INSTRUCTION TO SERVICE

ITS: 5481	
SECTION:	231 Coolant System
WRITTEN BY:	Mike Pearson
SUBJECT:	Rework OK6 Transmission Cooler Wire Harness UV Damage

Figure 2: EMP Rooftop Transmission Oil Cooler Main Harness Layout

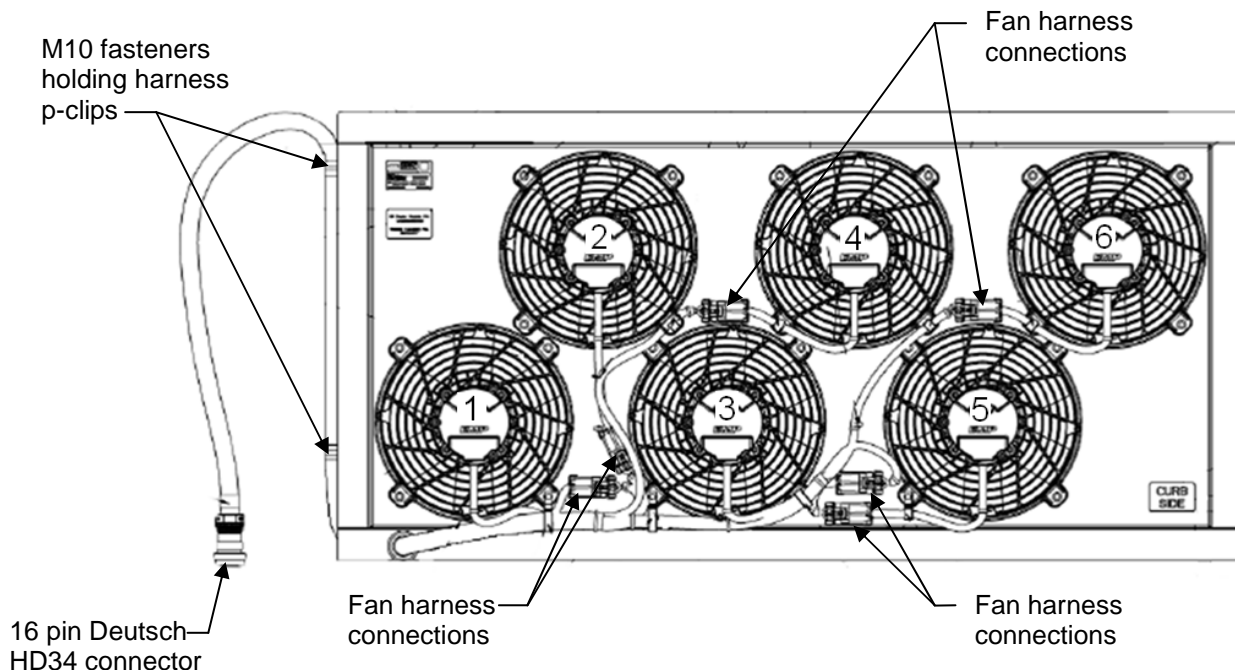
6. **Main Harness Removal:**
 - a. Disconnect the 16 pin Deutsch HD34 connector from the bulkhead connector on the driver's side of the bus. This requires a twisting motion in the counterclockwise direction.

- b. Remove the two M10 fasteners attaching the main harness p-clips to the oil cooler frame. These are on the driver's side of the Kit. Reserve the fasteners for reassembly.

- c. Disconnect each of the fans from the main wire harness by depressing the locking tab and pulling back on the harness connector body, pulling the connector body off the shroud.

- d. Cut and remove the cable ties attaching the harness to the shroud in each of the two locations; between fans 1, 2 and 3 and between fans 3, 4 and 5.

- e. Remove the main harness from each of the 8 J-clips by bending the J-clips away from the fan shrouds they are attached to. Discard the removed harness.

Figure 3: Close Off Plate Locations

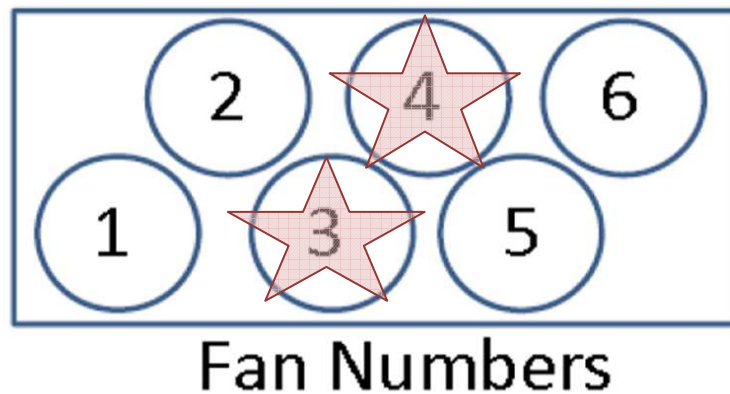
- a. Install the 2 closing plates at the locations shown in Figure 3 in place of fans 3 and 4.

Fig. 6b: Seal Visible, Incorrect

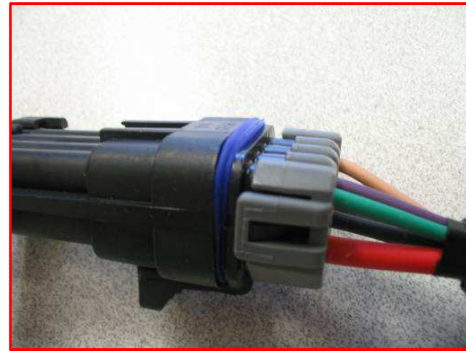
NOTE: When connecting Main Harness to Fan Harness, the connector is seated when you will hear or feel a “click”. Make sure the seal is not visible. If there is blue seal visible after the connector is seated then the connection will not be sealed and be compromised (Figures 6a and 6b).

SUMMARY IMAGES:

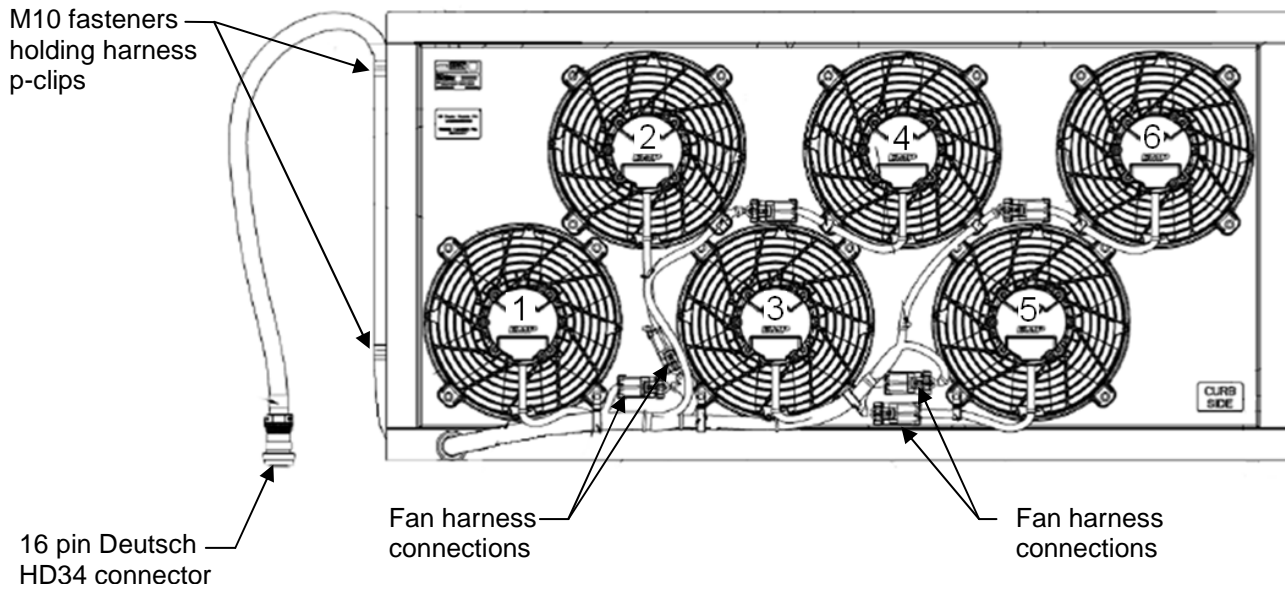
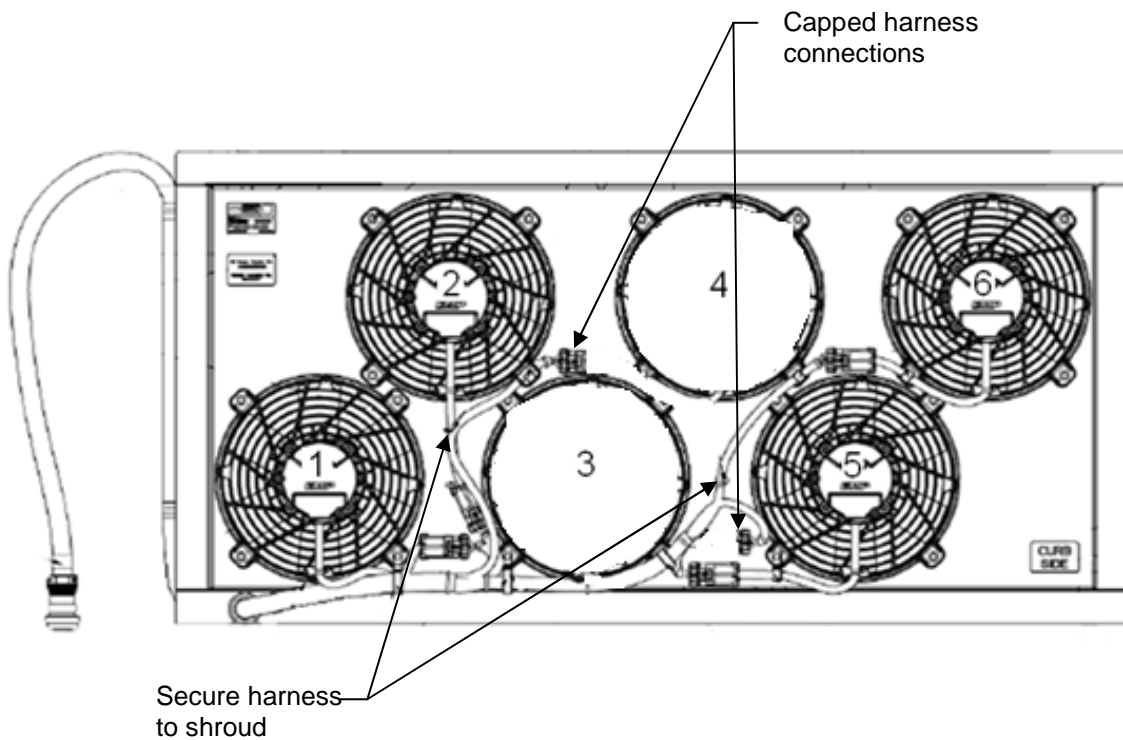
After more in-depth analysis of new production and to improve the overall simplicity of the system, New Flyer and EMP have determined the cooling demand only requires 4 fans, versus the current 6 fan setup. As a result, starting in year 2014 New Flyer production will only have a 4 fan system.

To remove the risk of having inoperable fans, the OK6 main harness will be replaced on subject units; the existing 6 fans will be replaced with 4 new or reworked fan assemblies depending on the severity of damage, 2 cover plates and all necessary hardware for the rework.
